**Addendum No.:** **2, E2094, Financial Project # 21149425201, Federal ID # 8887-640-A**  
Construction of 5' concrete sidewalk (5' Wide by 4" Thick) on Pratt Street beginning West of Polk Street and ending at SR 100 in Starke, Bradford County

The Work Class of **4.1.2 Minor Bridge Design** has been added to this project. The following changes have been made in the Request for Proposal for E2O94.

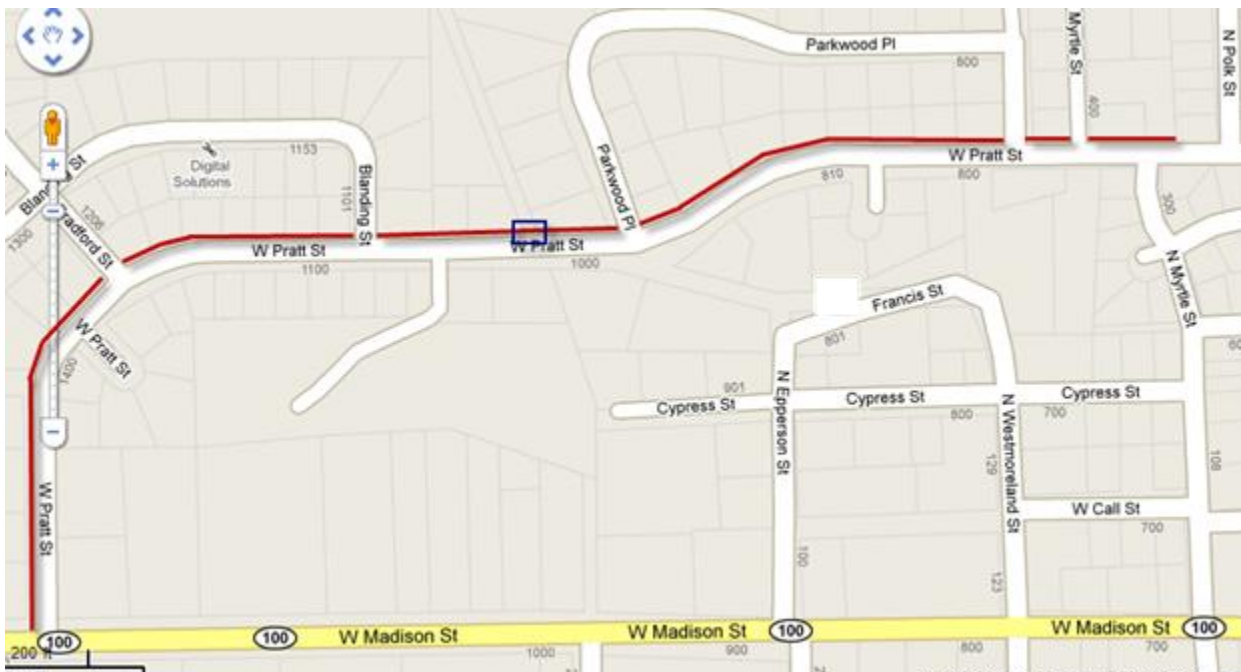
The Florida Department of Transportation (Department) has issued this Request for Proposal (RFP) to solicit competitive bids and proposals from Proposers for the construction of a 5' concrete sidewalk with a pedestrian bridge on Pratt Street beginning at State Road 100 and ending West of Polk Street in Starke, Bradford County, Florida.

Legend:

### Red Lines – Install Sidewalk

### Blue Box – Install Pedestrian Bridge
